**Supplemental Environmental Assessment of a
Marine Geophysical Survey by the R/V *Marcus G. Langseth*
in Southeast Asia, March–July 2009**

27 March 2009

LGL Report TA4553-3

FIGURE 1. Study area and proposed seismic transect lines for the TAIGER survey in SE Asia, revised based on public comments submitted to NMFS. Different colored lines correspond to the various legs of the cruise [see text]. Leg 3 is not shown as it does not involve seismic acquisition.

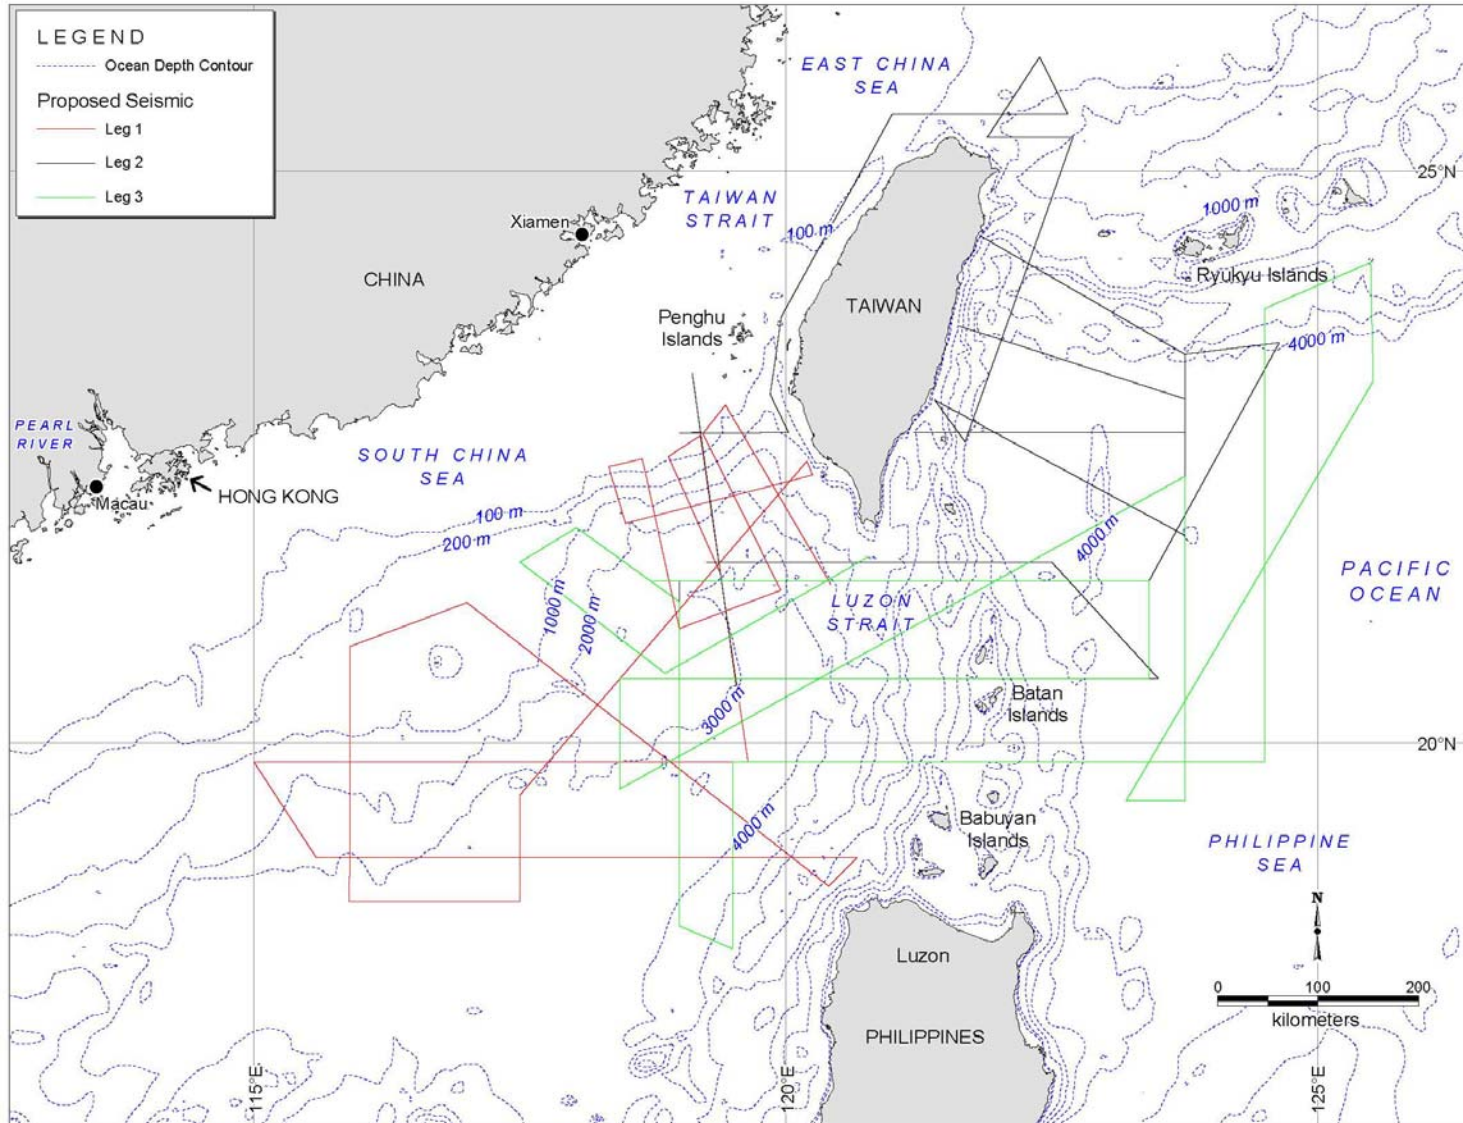
Many of the comments, including some of those from the Eastern Taiwan Strait Technical Advisory Working Group (ETSSTAWG), the Hong Kong Dolphin and Conservation Society (HKDCS), Humane Society International (HSI), Dr. John Wang (JW), the Natural Resources Defense Council (NRDC), and Wild at Heart (WAH), concerned possible effects of the seismic surveys on the small population of ~100 Indo-Pacific humpback dolphins (*Sousa chinensis*) that occurs along a ~100 km stretch of the west coast of Taiwan, from Taixi to Tongshiao (Wang et al. 2007). That population, the Eastern Taiwan Strait subpopulation, is considered Critically Endangered on the IUCN Red List of Threatened Species (IUCN 2008). The shallow waters off the west coast of Taiwan are also inhabited by the finless porpoise (*Neophocaena phocaenoides*), considered Vulnerable by IUCN (2008).

Other comments expressed concern about the mainland side of Taiwan Strait and shallow waters of the South China Sea. The Jiulong River Estuary, on the mainland side of Taiwan Strait at ~24.5°N, is habitat for another subpopulation of ~90 *Indo-Pacific humpbacked dolphins* (Chen et al. 2008 in JW comments). Winter breeding grounds of the *western gray whale* are not known, but are thought to be located in the South China Sea, along the coast of Guangdong province and Hainan (Wang 1984 and Zhu 1998 in Weller et al. 2002a; Rice 1998). Also, the migration route of the gray whale is ill defined, but very likely extends through Taiwanese waters, probably through the Taiwan Strait. Their occurrence there is possible from December to April. If migration timing is similar to that of the better-known eastern gray whale through similar latitudes, southbound migration probably occurs mainly in December–January, and northbound migration mainly in February–April, with northbound migration of newborn calves and their mothers probably concentrated toward the end of that period. Even during migration, gray whales are found primarily in shallow coastal waters. Shallow, coastal waters of the South China Sea are also inhabited by one of the three populations of the *finless porpoise*.

Other concerns were expressed about the survey line that was parallel to and within a few km of the east coast of Taiwan because of potential effects on coastal species and those that frequent the shelf break and steep slopes, e.g., beaked and sperm whales. The continental shelf is narrow there (Fig. 1).

Another concern was raised in several comments (JW, NRDC) about survey lines scheduled for Leg 2 (20 April to 7 June) approaching humpback whale breeding areas in the Babuyan and Ryukyu Islands. In fact, the humpback whales that winter and calve in the Ryukyu Islands are near Okinawa (Nishiwaki 1959; Rice 1989; Darling and Mori 1993), some 400 km north of the most northerly survey. However, a small population of humpbacks does winter and calve in the Babuyan Islands in Luzon Strait (Acebes and Lesaca 2003; Acebes et al. 2007). The whales may arrive in the area as early as November and leave in May or even June, with peak occurrence during February through March or April (Acebes et al. 2007).

L-DEO has negotiated with the project's principal scientists to modify the cruise plan and adopt more precautionary mitigation measures. Off Taiwan's west coast, the cruise tracks have been re-routed offshore by ~20 km to protect the critically endangered *Sousa* population and the finless porpoise, as well as ease potential pressure on other coastal species (Fig. 1). Thus, it is now planned to maintain the precautionary buffer recommended by ETSSTAWG in their comments to NMFS, "at least 13 km and perhaps a more precautionary 15 km of the ETS *Sousa* population—meaning up to around 20 km from shore".

Because of these concerns about effects of the proposed surveys on gray whales, Indo-Pacific humpbacked dolphins, and finless porpoises, the proposed survey lines in the South China Sea south of the Taiwan Strait have been re-routed so that they are now located in water depths >200 m, as recommended by NRDC. The seismic lines in western Taiwan Strait have been dropped (Fig. 1).

The proposed survey line paralleling the east coast of Taiwan has also been moved offshore by more than 20 km to decrease potential impacts on species that occur in coastal waters and over the continental slope (Fig. 1).

To mitigate against the potential effects of the surveys on humpbacks, particularly mothers and calves on the breeding grounds or during the beginning of migration to summer feeding grounds, the surveys that approach the Babuyan Islands have been rescheduled as late as possible, to Leg 4 (18 June–20 July).
